**STATE OF NORTH CAROLINA
UTILITIES COMMISSION
RALEIGH**

DOCKET NO. E-100, SUB 179

IN THE MATTER OF:)
Duke Energy Progress, LLC, and Duke)
Energy Carolinas, LLC, 2022 Biennial)
Integrated Resource Plans and Carbon)
Plan)

**COMMENTS AND ISSUES OF THE
CAROLINAS CLEAN ENERGY BUSINESS ASSOCIATION**

FIGURE 5 // Seasonal wind and solar complementarity in the Carolinas (winter/summer)⁷⁴

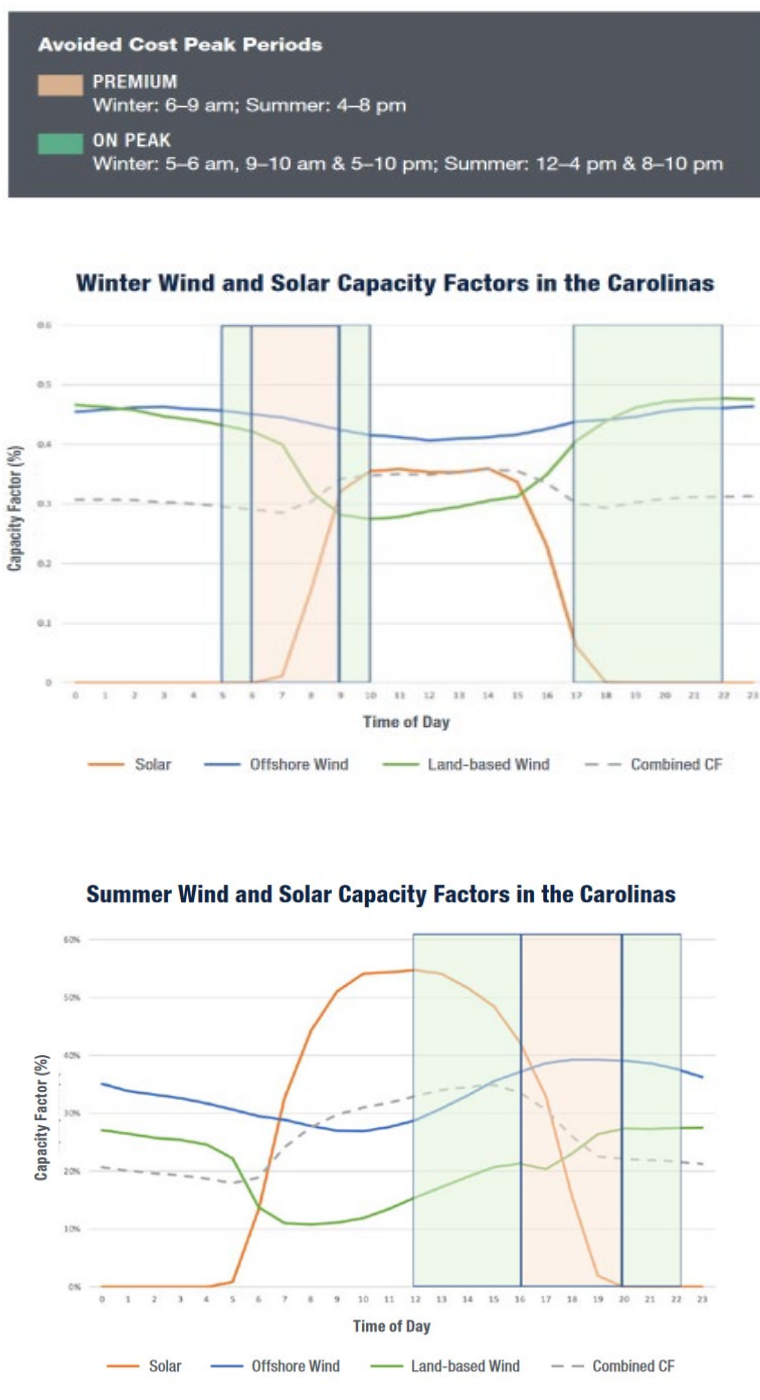
Moreover, offshore wind and solar are complementary technologies. With a high capacity factor of between 40 and 50 %, offshore wind in the Carolinas could play a significant role in meeting peak load in the winter and reducing variability in a similar manner to that traditionally seen in coal and gas resources.⁸⁰ The figure below from the Southeastern Wind Coalition's report show how a hypothetical mix of solar, onshore wind and offshore wind results in more on peak generation in both winter and summer seasons, as well as fewer fluctuations.⁸¹
